UN# 07-003

Subject: UniStar Nuclear, NRC Project No. 746
Submittal of the Published UniStar Nuclear Topical Report No. UN-TR-06-001-A,
"Quality Assurance Program Description," Revision 0

**UniStar Nuclear Response to NRC Request for Additional Information Regarding
Proposed Revision 1 of the UniStar Nuclear Quality Assurance Program Description
Topical Report UN-TR-06-001**

Figure A-1

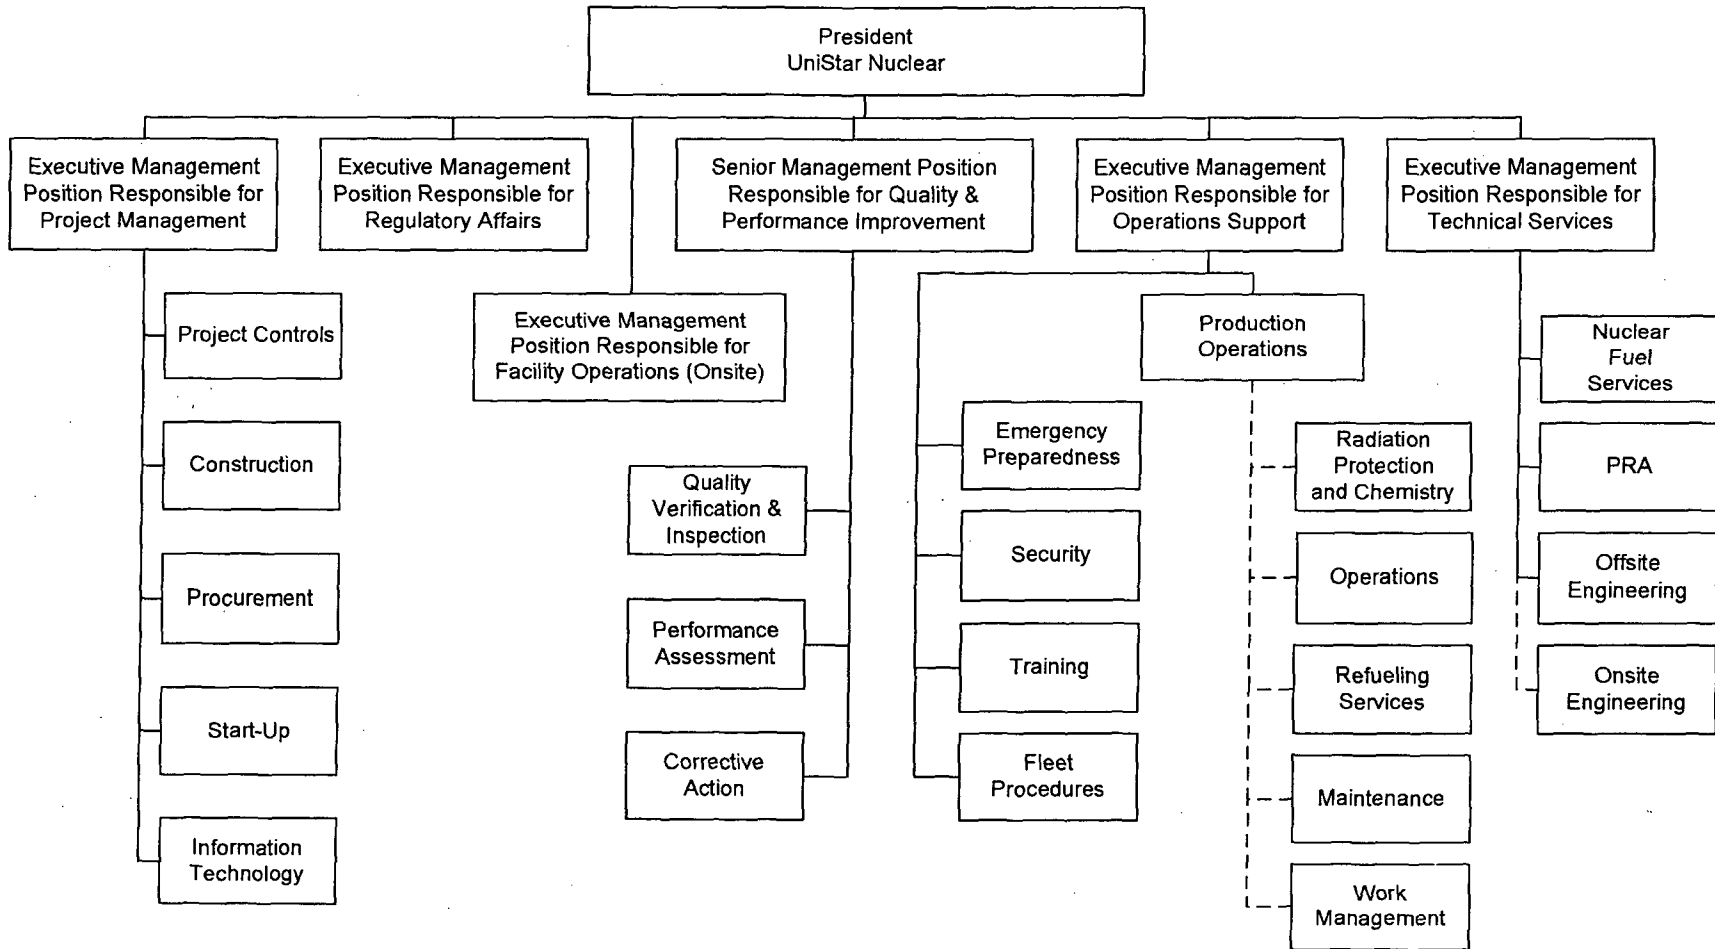
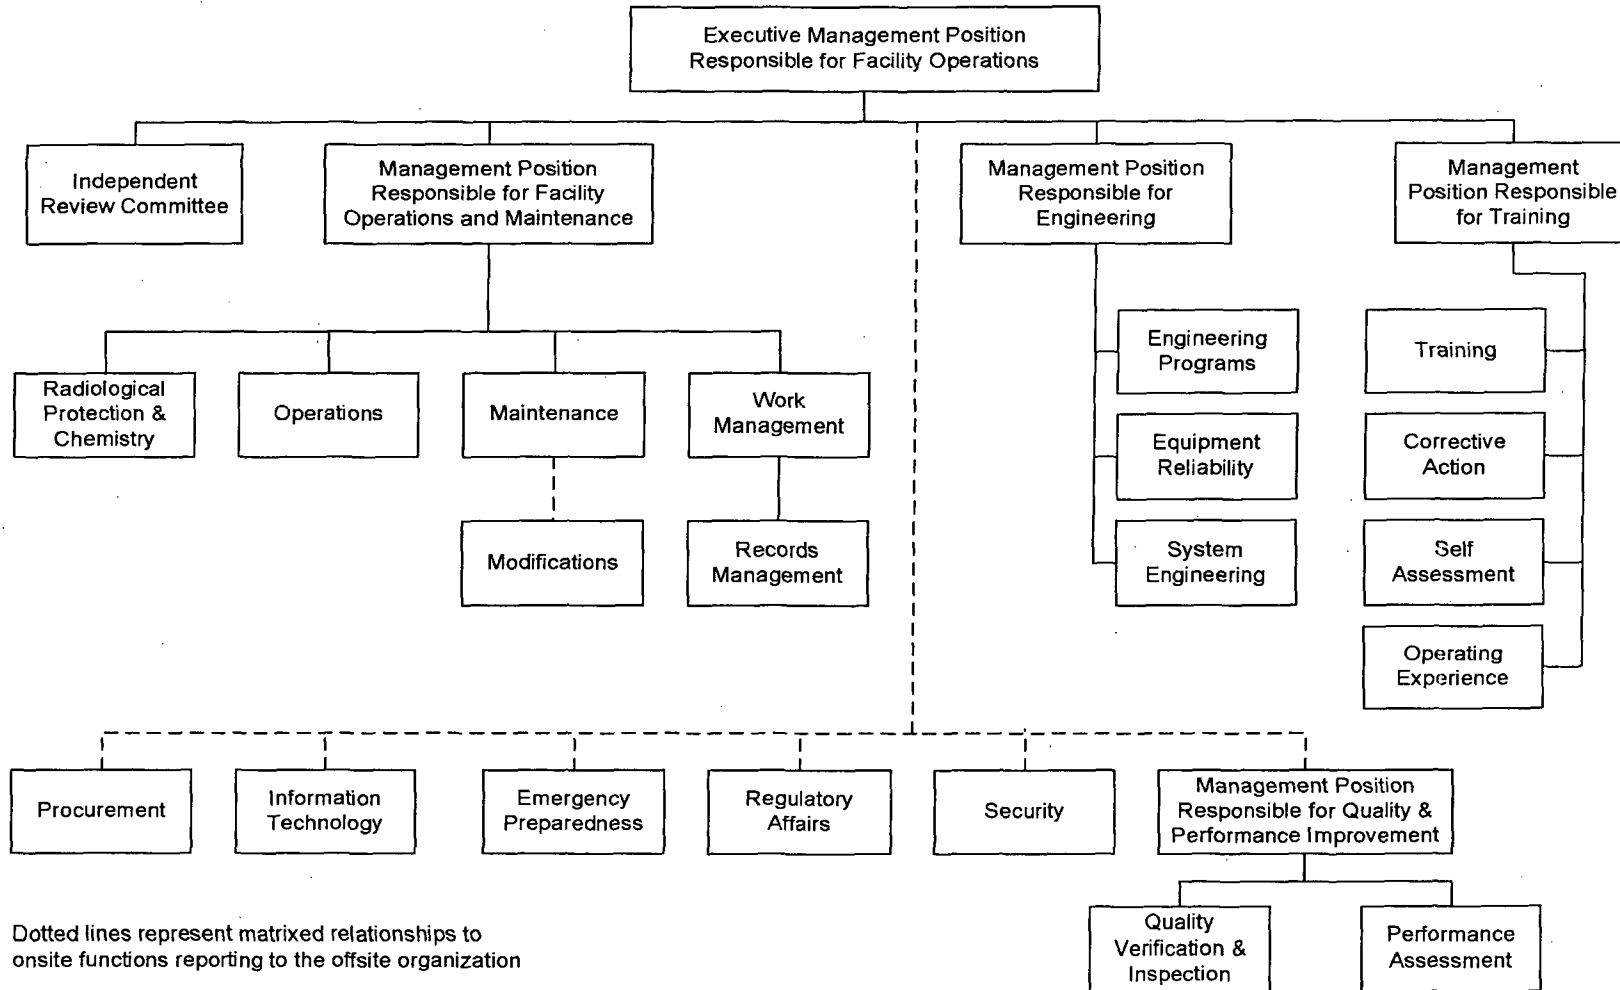
- b. The Corporate and Technical Support Functions section: 1) does not address the functional responsibilities of the Senior Management position responsible for Quality and Performance Improvement depicted on Figure 2; and 2) does not state whether the management positions are onsite or offsite. Additionally, for each management position described in this section, there is a statement that some of these responsibilities may be assigned to the Executive Management position responsible for Facility Operations. It is not clear how a specific site Executive Manager can be responsible for their facility operations and corporate functions.

- c. The Operating Organization and Functions section: 1) does not state whether the Executive Management position responsible for Facility Operations and the Management Position responsible for Facility Operations and Maintenance are onsite or offsite; 2) does not have the same title descriptions for Training and Engineering as depicted in Figure 3; and 3) does not specify to which corporate management position (offsite) the site management position for training functionally reports.

- d. The QA Organization and Functions section: 1) does not state whether the management position, the QA organization, and the position added to the QA organization after transition to operations are onsite or offsite; 2) does not depict the QA organization on Figure 1; and 3) does not clearly indicate whether the position added to the QA organization after transition to operations is a management position.

2. Section A, including the organization charts, have been revised to better delineate the Offsite and Onsite organizations and reporting relationships.

1. Section A, including the organization charts, have been revised to better delineate the Offsite and Onsite organizations and reporting relationships.

3. The position description and organizational charts have been revised.

1. Section A, including the organization charts, have been revised to better delineate the Offsite and Onsite organizations and reporting relationships.

3) The position is a management position. The description and organization chart has been revised to so indicate.
